# CONTROL ROOM DESIGN REVIEW

## Summary Report

BEAVER VALLEY POWER STATION UNIT 2

**CONTROL ROOM  
DESIGN REVIEW**

FIGURE 5.3

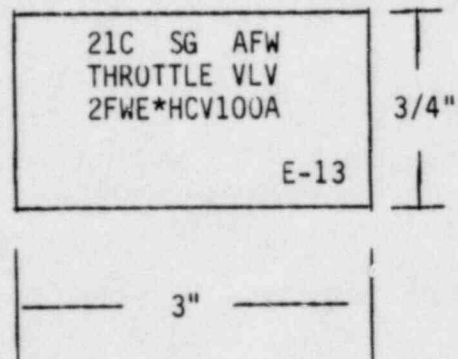
EXISTING NAMEPLATE:

PROPOSED NAMEPLATE:

FIGURE 5-4

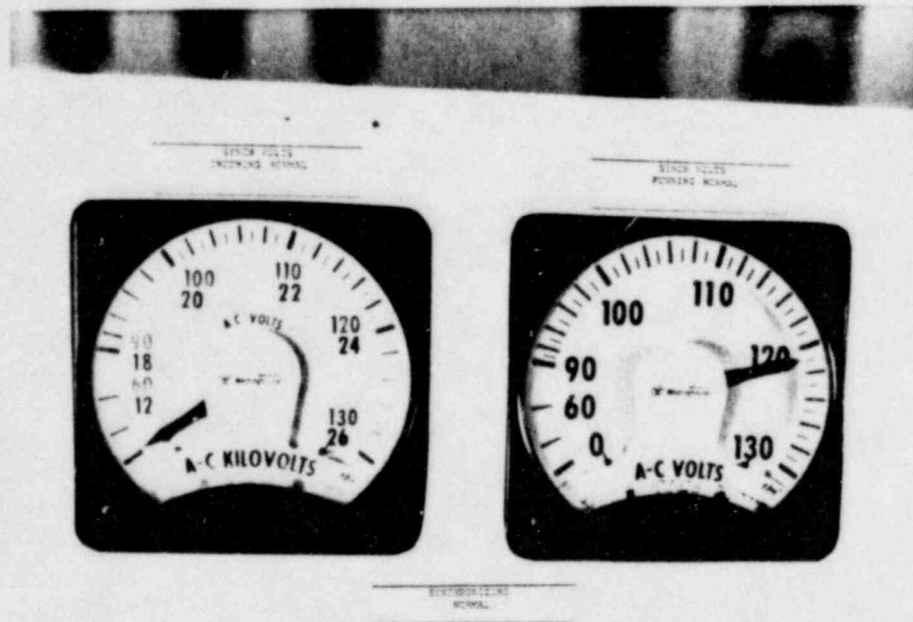
HED No. 2\*C\*-2217

The "SYNCH VOLTS - INCOMING NORMAL" indicator is a multiscale indicator (violates NUREG-0700 criterion 6.5.1.4 f). It is also different than the "SYNCH VOLTS -RUNNING NORMAL" indicator. These two indicators should have identical scales.

**Resolution:**

FIGURE 5-5

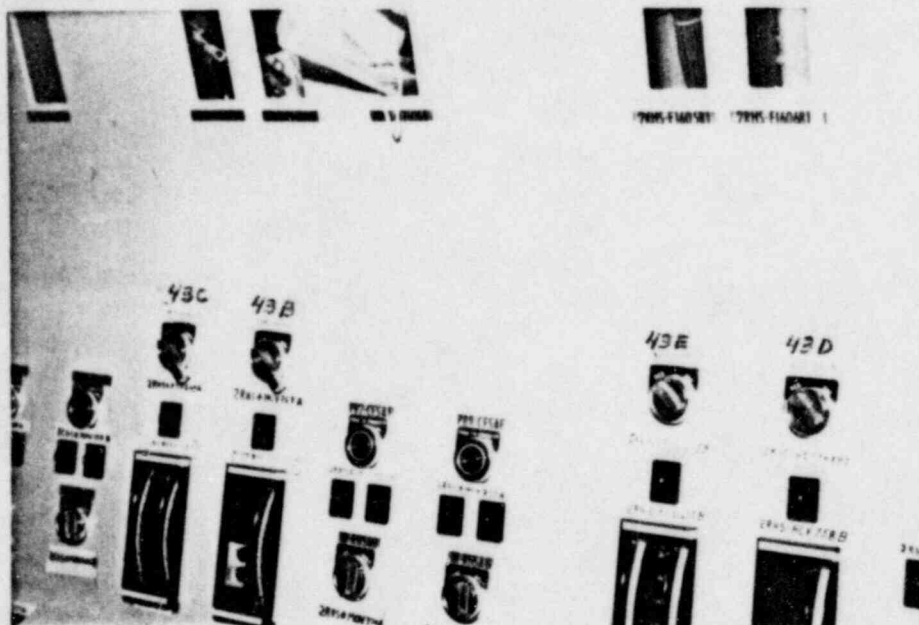
HED No. 2ES4 - 3023

The emergency shutdown panel uses two different types of switches for transferring control from the main control board (MCB) to the shutdown panel (SDP). (Violates NUREG-0700 criterion 6.4.1.1). The two controls on the left (43C and 4B-CESNL) are preferred (external handle). The two on the right (43E and 43D -CESNL) are of the type normally anticipated when controlling valves.

**Resolution:**

FIGURE 5-6

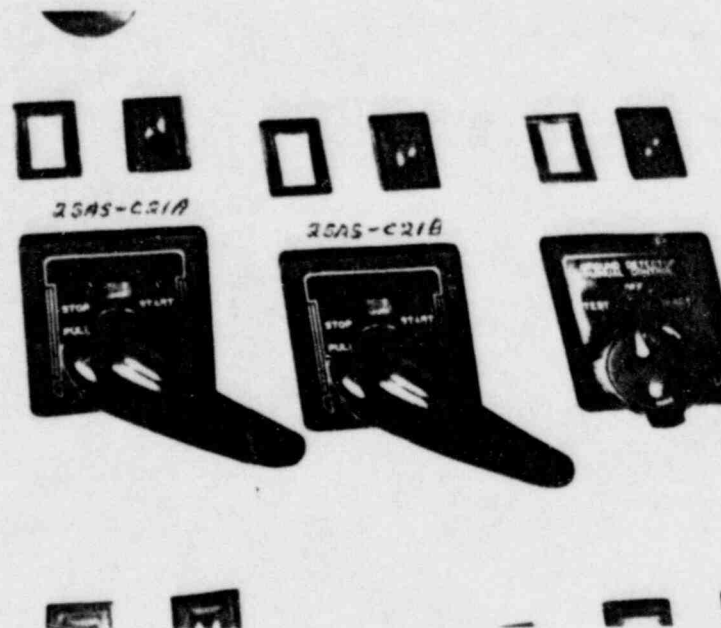
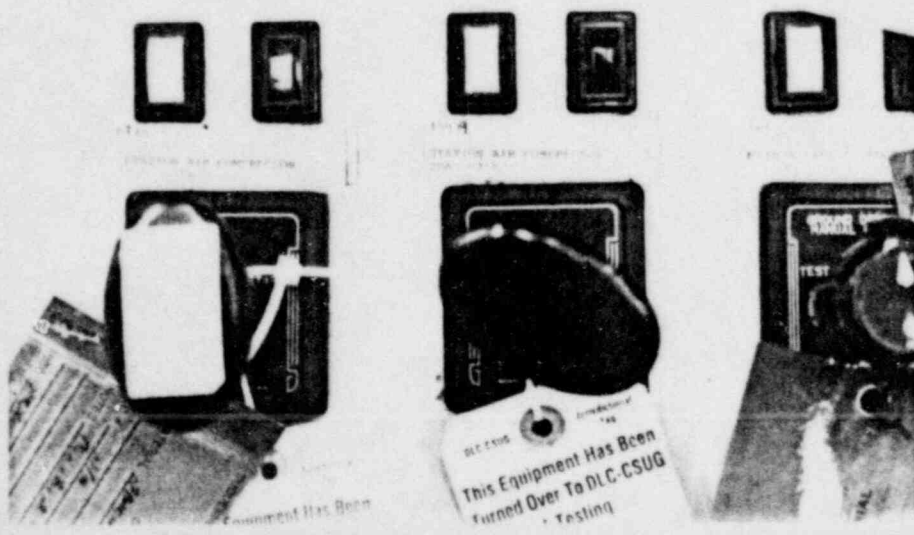
HED No. 2BC3 - 3025

When the control for 2SAS - C21A (Station Air Compressor) is in "PULL-TO-LOCK", 2SAS - C21B cannot be placed in "START" because the control handles interfere with each other (violates NL REG-0700 criterion 6.4.1.1).

**Resolution:**

Install oval-shaped control handles that will not interfere with each other, as shown below.

FIGURE 5-7

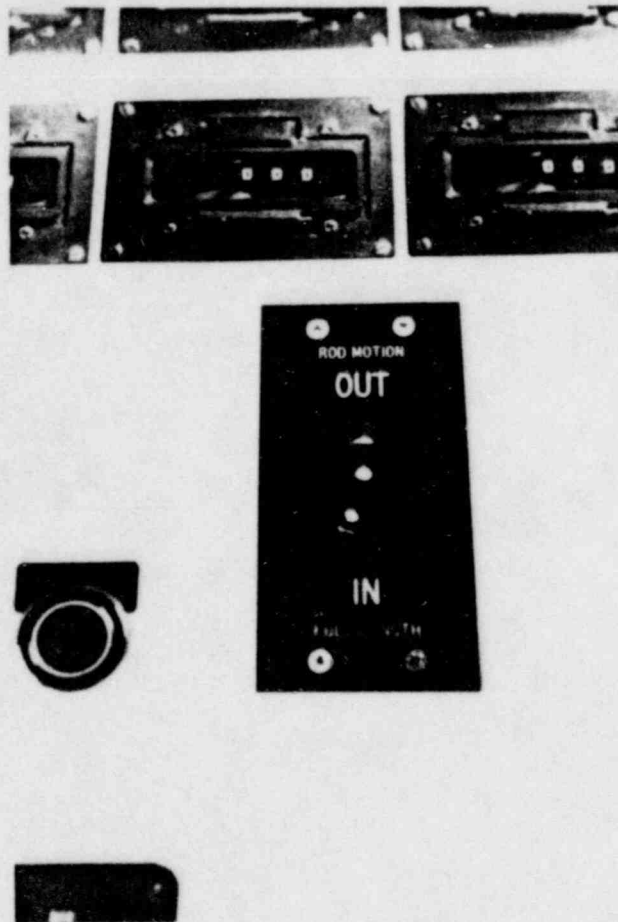
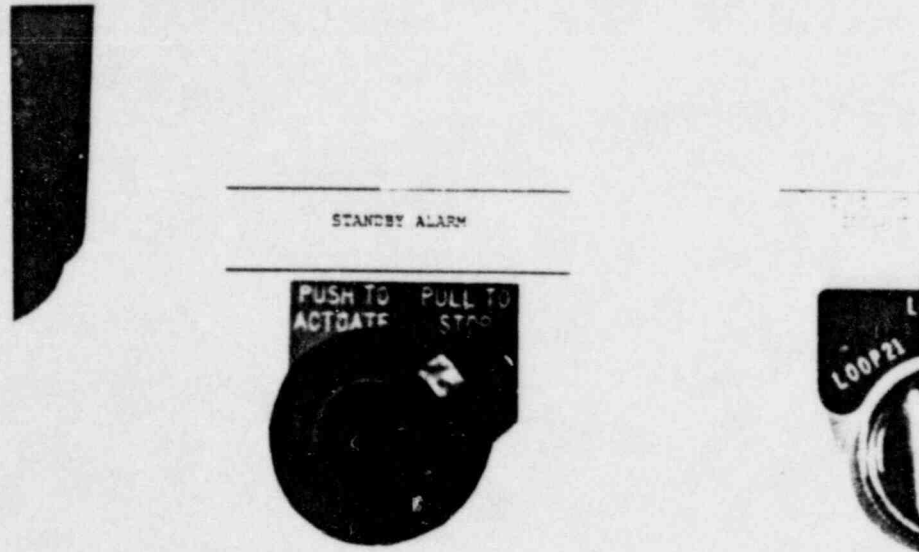
HED No. 2BB2 - 3301

The existing rod position controller is inconsistent with operator's expectations (violates NUREG-0700 criterion 6.4.2.1). Also, the positions are reverse to that of Unit 1.

**Resolution:**

The switch contacts and control labelling will be reversed so that pushing lever forward will push rods IN and pulling lever will pull rods OUT.
